Sacramento Municipal Utility District Headquarters Building and Site Rehabilitation Project

Final Initial Study and Mitigated Negative Declaration • March 2015

**Final
Initial Study and Mitigated Negative Declaration**

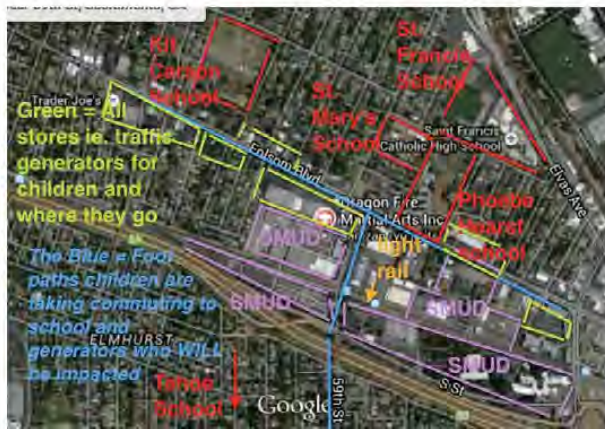
There are no side walks no crosswalks to major shopping centers ie traffic generators on , on/off ramps. There are no bike lanes on bridge yet the space is available for one to connect to traffic generators. Children commute to school here daily. Light rail stop is here too . HIGH pedestrian zone. These generators serve over 3 neighborhoods.

Pedestrian scale light the length of 59th street in keeping with the area's historical aesthetic in material color and type of shade is required by CEQA. Increased undisclosed foot traffic by SMUD will require lighting in keeping with current historical lighting aesthetic for the neighborhood. Lighting that will not take away from the historical lights in place both Tahoe Park and East Sacramento residential streets thereby impacting the areas historical value.
